Consent Amendment: Sandy Spring Townhomes: Site Plan No. 82016001A

A. Sandy Spring Townhomes: Site Plan No. 82016001A:

Figure 4 – Proposed turnaround/plaza

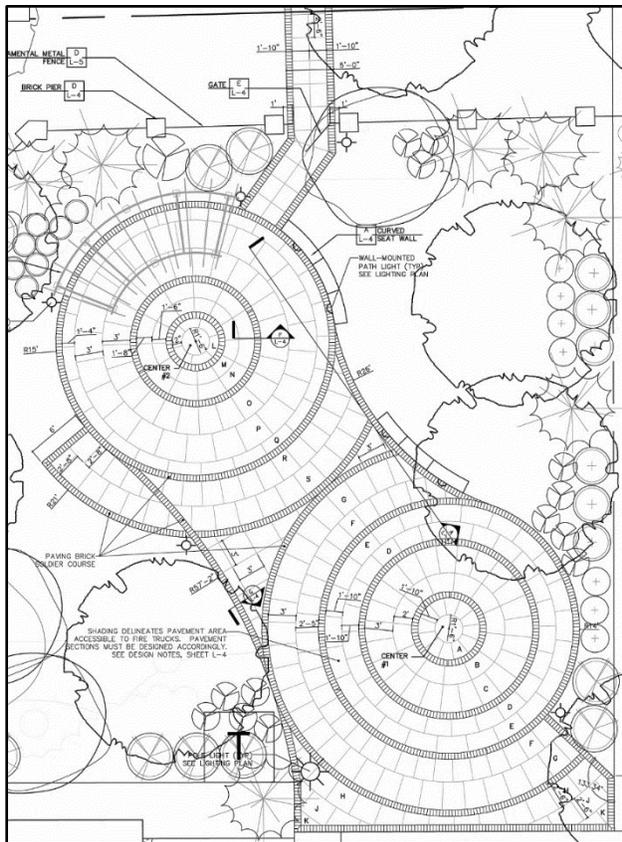
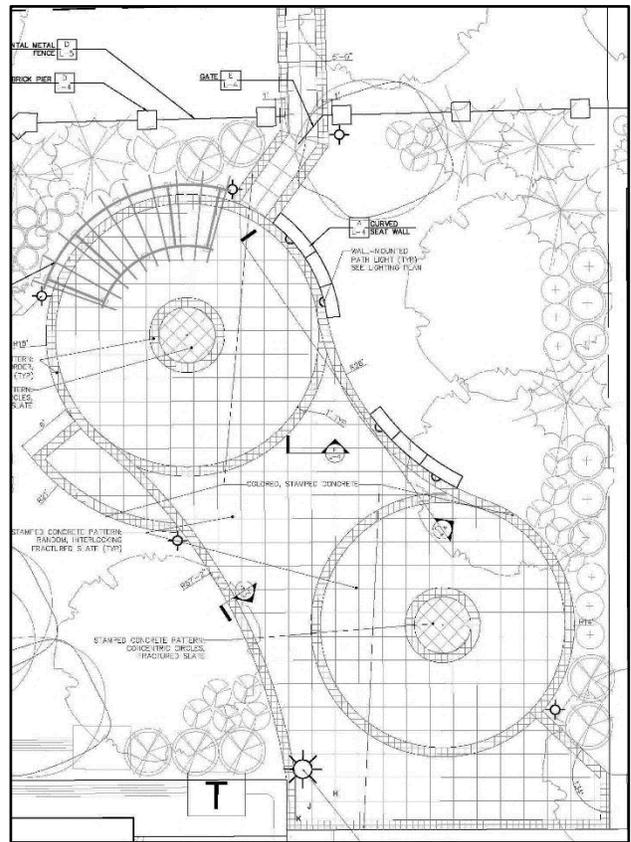
The Applicant has requested an additional change to the site plan details for the combined emergency vehicle turnaround/plaza that is shown in the primary common open space parcel (Community Green) in the northwestern corner of the site. The approved site plan specified a design of stone pavers and brick inlay that served the dual purpose of being supportive of a fire truck while providing aesthetic value to the open space. The Applicant through this Amendment is asking to change the materials to a poured colored stamped concrete to increase the durability of the initial surface and to reduce future maintenance costs associated with the plaza. The Applicant will use a colored concrete which will be stamped with a fieldstone texture for the majority of the surface within the open area. To retain the effect of the original design with the edging details, the Applicant has agreed to using a similar stone textured border stamp along the concrete edges, as well as to continue some of the pattern of circles shown on the original plans (Figure 3 and 4). Staff believes the proposed design and materials is substantially similar in quality and purpose to the original proposal, and will likely reduce the future maintenance to the HOA, therefore, Staff supports this modification.

This Amendment changes the material used in the emergency vehicle turnaround/public plaza shown on the site plan from inlaid pavers to a colored and stamped patterned concrete. The pattern chosen continues to provide visual interest to the emergency vehicle turnaround, and the material used has greater durability and less long term maintenance concerns as the pavers. The Amendment still meets the landscaping requirements and standards and continues to adequately activate the Community Green.
